REPORT TO THE CALGARY PLANNING COMMISSION

| DEVELOPMENT PERMIT | ITEM NO: 05 | |
|--------------------|-------------|------------------|
| | FILE NO: | DP2012-3135 |

BELTLINE (Ward 8 - Alderman Mar)

New: Multi-Residential Development (158 units)

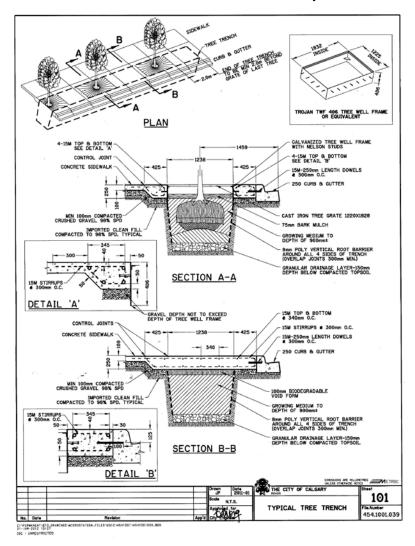
a. Remove shrubs and bike racks from 2.134 metres bylawed setback area along 9 Street SW.

- -Portions of the proposed bike racks are still shown to encroach within said setback lands. Move the bike racks to be completely behind the setback lands.
- -DP401 & DP402 show steps and planters within the setback lands which cannot be permitted and shall be addressed.
- b. Reconfigure the adjacent laneway flare so that the flare width is 1.0m and as to connect flare from edge of curb to ultimate property line (bylaw setback line). Show this revision on all relevant plans (Site Plan, Landscape Plan, etc.).

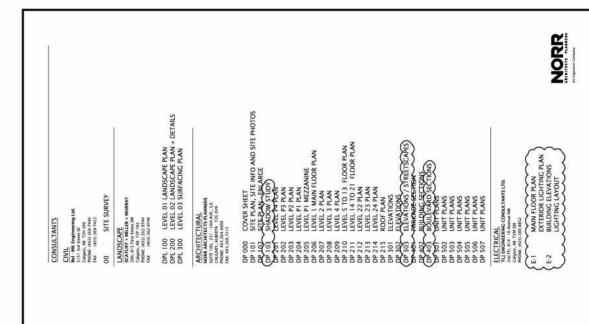
35. No direct vehicular access will be permitted to either: 9 Street SW or 12 Avenue SW
